**Re: Whirlpool Corporation, Fort Smith, Arkansas  
Final Remedy Work Plan – Response to Comments  
CAO LIS 13-202  
EPA No. ARD042755389  
AFIN No. 66-00048**

On behalf of Whirlpool Corporation, ENVIRON International Corporation (ENVIRON) has prepared this written response to your letter dated March 17, 2014. ENVIRON's response follows for each item.

Figure 1 – Injection Well Array Locations Installed February, March 2014

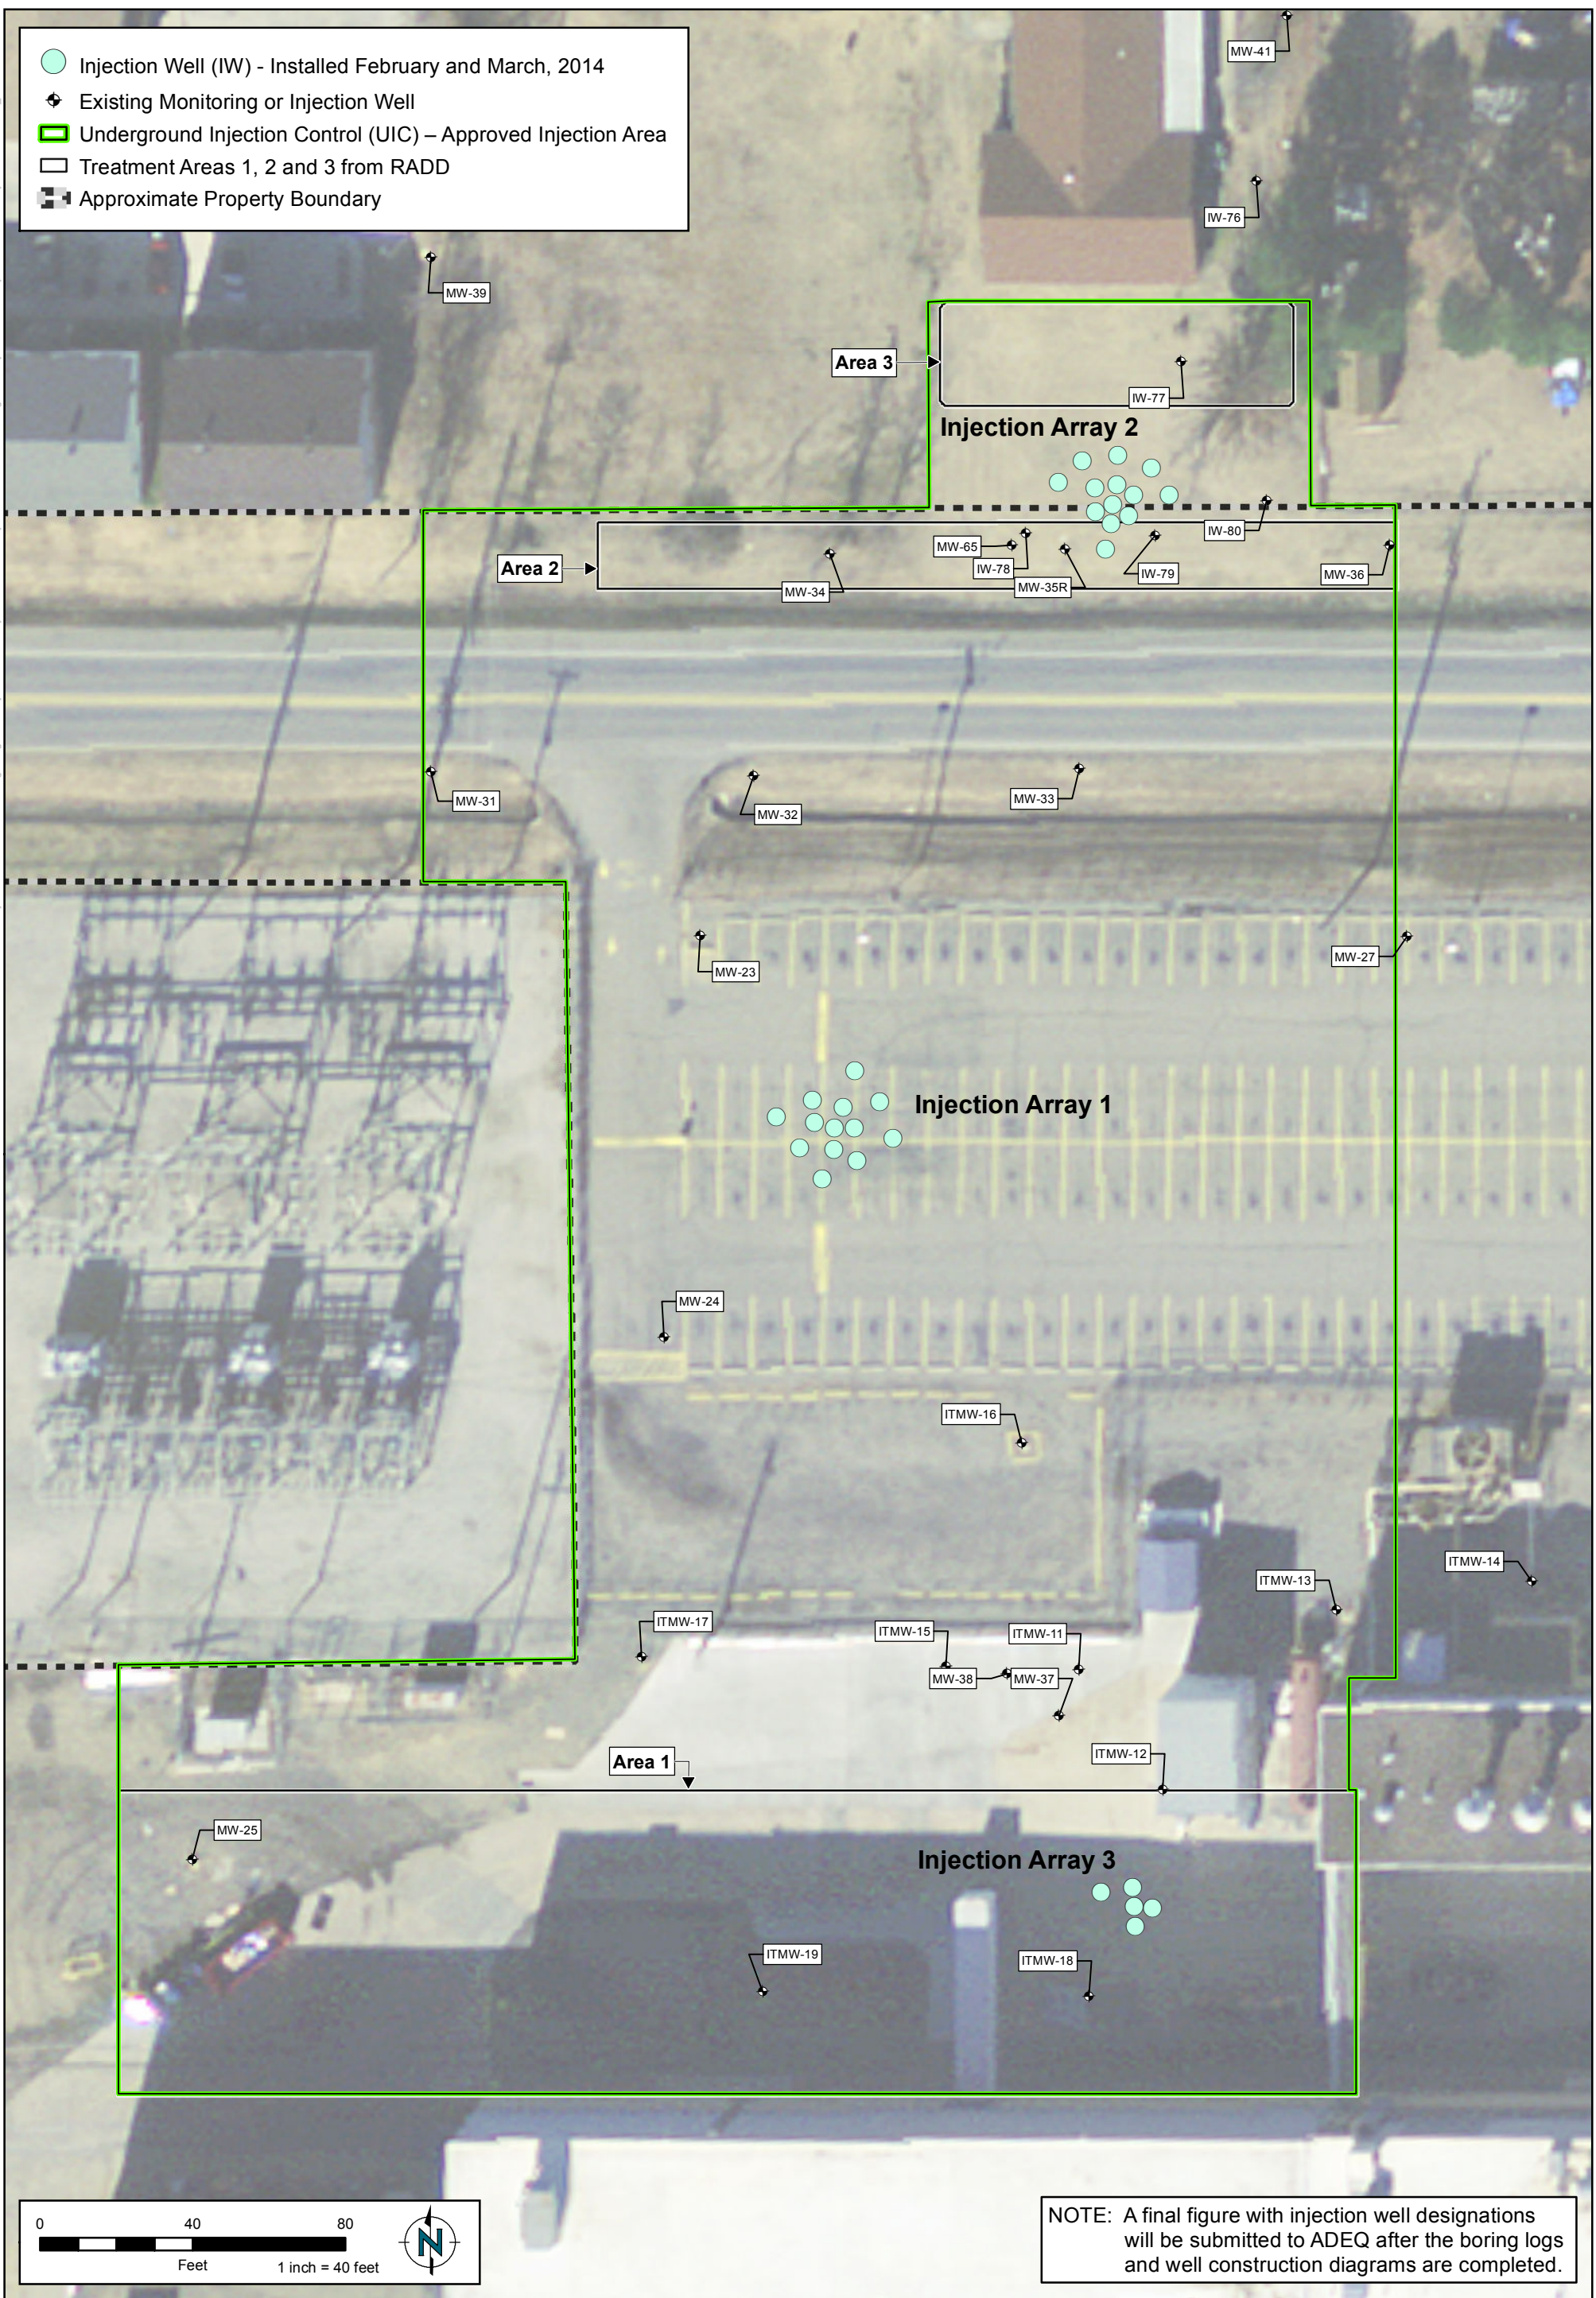
Please provide details pertaining to injection points, borings, monitoring wells, and temporary monitoring points. At a minimum, please include the following data:

- Location
- Proposed depth of injection, screen and sample collection
- Planned volume and rate of injection

The current remedy implementation phase, which commenced on February 24<sup>th</sup>, 2014, includes three nested injection arrays as shown on the attached figure 1 consisting of a total of 30 injection wells. The basis for selection of the location of the subject injection arrays and current injection implementation phase was presented to ADEQ during a conference call on March 11, 2014. The location of the well arrays was provided to the ADEQ's David Gillespie and Charles Johnson on March 11, 2014. Injection Array 1 is located at the neck area of the groundwater plume and includes twelve injection wells; the injection efforts in the neck area are supplemental to the remediation work considered in the Remedial Action Decision Document (RADD). Injection Array 2 is targeted at Areas 2 and 3 and includes thirteen injection wells, which accounts for nearly 20% of the 69 injection points considered in the

RADD for Areas 2 and 3. Injection Array 3 is located in Area 1 and includes five injection wells.
